Access Compliance Report Public Rights-of-Way (Curb Ramps)

Intersection ID: 12267 Main Street: CENTRAL AV Cross Street: LOUISE_AV Location: SW ADA ID: 9C49F64E0F77 Ramp Type: BlendTrans1 Initial Pass/Fail: Fail **Overall Compliance: No Severity Score:** 12.5

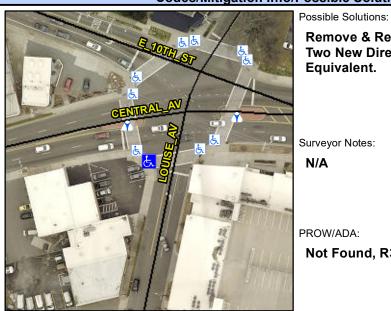
Not Found, R304.5.3

Field Measure	ments/C	ompo	nent Compliance	
Compliance Description		Data	Compliance Description		Data
N/A	Ramp Length (in)	72.0	Yes	BlendTrans Slope (%)	2.0
Yes	Ramp Width (in)	48.0	No	BlendTrans XSlope (%)	5.7
N/A	Flare Type LT	N/A	N/A	Flare Type RT	N/A
N/A	Flare Slope LT (%)	N/A	N/A	Flare Slope RT (%)	N/A
N/A	Flare Traversable LT?	N/A	N/A	Flare Traversable RT?	N/A
N/A	Landing Length (in)	N/A	N/A	DWS Provided?	N/A
N/A	Landing Width (in)	N/A	N/A	DWS Contrast?	N/A
N/A	Landing Slope (%)	N/A	N/A	DWS Length (in)	N/A
N/A	Landing X Slope (%)	N/A	N/A	DWS Full Width?	N/A
N/A	Landing Curb? (Y/N)	N/A	N/A	DWS Offset (in)	N/A
N/A	Shared Landing?	N/A			
N/A	Gutter Ponding?	N/A	N/A	Gutter Slope (%)	N/A
N/A	Gutter Lip Ht (in)	N/A	N/A	Gutter X Slope (%)	N/A
N/A	Painted X Walk1?	Yes	N/A	Painted X Walk2?	N/A
	X Walk 1 Direction	To NE		X Walk 2 Direction	N/A
	X Walk 1 Width (in)	144.0		X Walk 2 Width (in)	N/A
	X Walk 1 Slope (%)	5.4		X Walk 2 Slope (%)	N/A

X Walk 1 X Slope (%)	1.0		X Walk 2 X Slope (%)	N/A
N/A	Ramp inside XWalk1?	Yes	N/A	Ramp inside XWalk2?	N/A
	Road Slope (%)	1.0		Clear Space?	N/A
	Road X Slope (%)	5.4	N/A	Clear Space to XWalk (in)	N/A
N/A	Any Obstructions?	N/A	N/A	Storm Grate/Utility Hazard?	N/A
	Obstruction Type			Storm Grate/Utility Type	
		N/A			N/A
			Yes	Surface Condition? (G/P)	Good
			No	Curb Slope (%)	15.4

LOUISE AV Street 1 Name Stop Condition-Street 1 Signal Street 2 Name N/A Stop Condition-Street 2 N/A Remove & Replace Curb Ramp With Two New Directional Ramps or Equivalent.
